UNITED STATES PATENT AND TRADEMARK OFFICE

Office Action Summary	Application No.		Applicant(s)	
	10/606,350		MAEKAWA ET AL.	
	Examiner		Art Unit	
	James T. Nelson		3637

DETAILED ACTION

Hoffman, Fig. 2

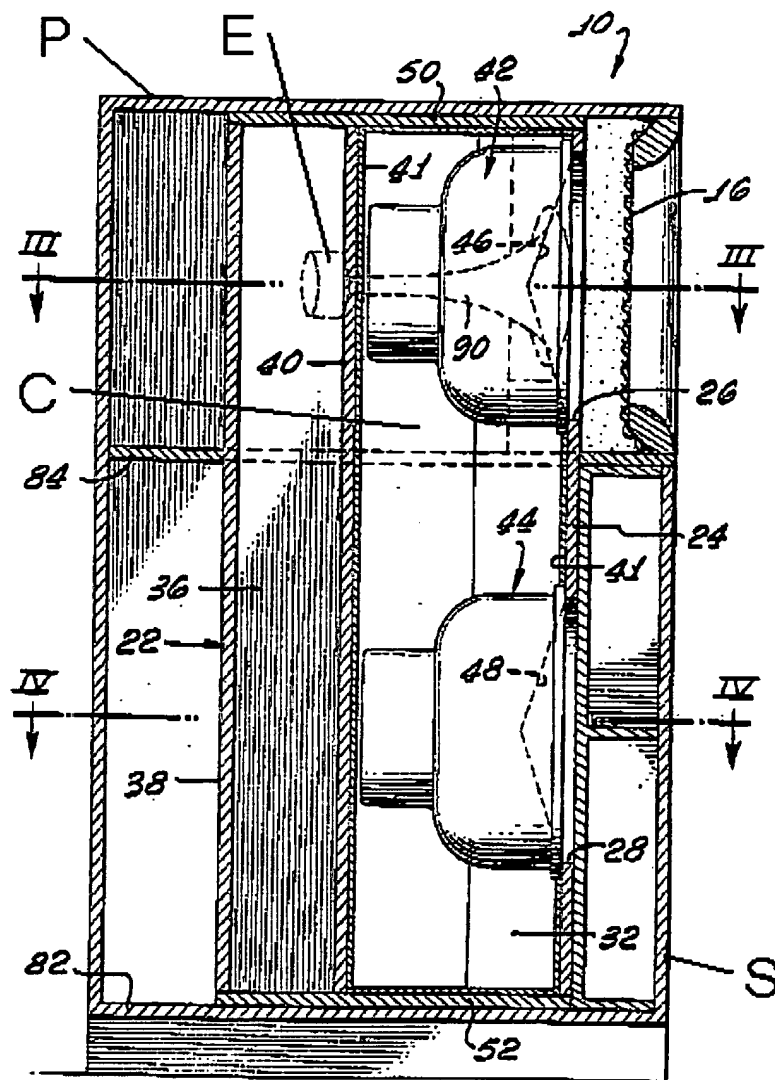
Regarding claim 1: In Fig. 2, Hoffman shows a speaker-provided mounting table (10) with a pedestal (P), a hollow-shaped support member (S) for supporting the pedestal (P), the support

member (S) also functioning as an acoustic pipe and a speaker unit (41) being equipped with a speaker (44) and attached to the support member (S).

Regarding claim 2: In Fig. 2, Hoffman shows a speaker-provided mounting table (10) according to claim 1, wherein the support member (S) is configured to function as an acoustic pipe with an acoustic capacity (C) associated with an acoustic pipe.

Regarding claim 3: In Fig. 2, Hoffman shows a speaker-provided mounting table (10) with a pedestal (P), a hollow-shaped support member (S) for supporting the pedestal, the support member (S) also functioning as an acoustic capacity (C) and a speaker unit (41) being equipped with a speaker (44) and attached to the support member (S).

Regarding claim 4: In Fig. 2, Hoffman shows a mounting table (10) according to claim 1, wherein the speaker unit (41) is composed of a dynamic electricity type of speaker (44).

Regarding claim 5: In Fig. 2, Hoffman shows a mounting table (10) according to claim 1, wherein the speaker unit (90) is composed of a piezoelectric type of speaker (E).

Regarding claim 9: In Fig. 2, Hoffman shows a mounting table (10) according to claim 3, wherein the support member (S) has an acoustic capacity (C) to cause a resonance with a vibration mass (48) of the speaker unit (44).

Regarding claim 6: In Fig. 2, Hoffman shows a mounting table according to claim 1, wherein the support member (S) is provided with an acoustic capacity cavity (C), but lacks an aperture port for outputting the sound emitted by the acoustic capacity cavity. In Fig. 2, Wilke teaches an aperture port (80) for outputting the sound emitted by the acoustic capacity cavity (5). It would have been obvious to one skilled in the art at the time of invention to combine the aperture port of Wilke with the support member of Hoffman in order output sound emitted by the acoustic capacity cavity.

Regarding claim 7: In Fig. 2, Hoffman shows a mounting table according to claim 1, with a support member (S), but lacks an acoustic pipe for causing a pipe resonance therein and an aperture port for outputting sound generated by the pipe resonance. In Fig. 2, Wilke teaches an acoustic pipe (70) for causing a pipe resonance therein and an aperture port (80) for outputting sound generated by the pipe resonance. It would have been obvious to one skilled in the art at the time of invention to combine the acoustic pipe and aperture port of Wilke with the support member of Hoffman in order to create a pipe resonance and output the sound generated by the pipe resonance.

Regarding claim 8: In Fig. 2, Hoffman shows a mounting table according to claim 2, wherein the support member (S) is provided with an acoustic capacity (C), but lacks an acoustic pipe, which causes a resonance therein, and an aperture port for outputting sound generated by the resonance. In Fig. 2, Wilke teaches an acoustic pipe (70), which causes a resonance therein, and an aperture port (80) for outputting sound generated by the resonance. It would have

been obvious to one skilled in the art at the time of invention to combine the acoustic pipe and aperture port of Wilke with the support member of Hoffman in order to create a pipe resonance and output the sound generated by the pipe resonance.

Regarding claim 10: In Fig. 2, Hoffman, as modified by Wilke, shows a mounting table (10) according to claim 6, wherein the support member (S) is configured to be driven by the speaker unit (44) so that the support member (S) has a function of any one of a Helmholtz resonance, a pipe resonance, or a resonance being caused on both of the speaker and the acoustic capacity (C). It would have been obvious to one skilled in the art at the time of invention to incorporate the Helmholtz resonance or pipe resonance of Wilke into the support member and acoustic capacity of Hoffman in order to achieve the desired acoustical properties.

Regarding claim 11: In Fig. 2, Hoffman, as modified by Wilke, shows a mounting table (10) according to claim 6, wherein the hollow-shaped support member (S) is formed to have a fundamental frequency causing a pipe resonance, the fundamental frequency being set to a limit to replay a lower-band sound. It would have been obvious to one skilled in the art at the time of invention to combine the acoustic features of Wilke with the hollow-shaped support member of Hoffman in order to achieve a pipe resonance set to replay a lower-band sound.
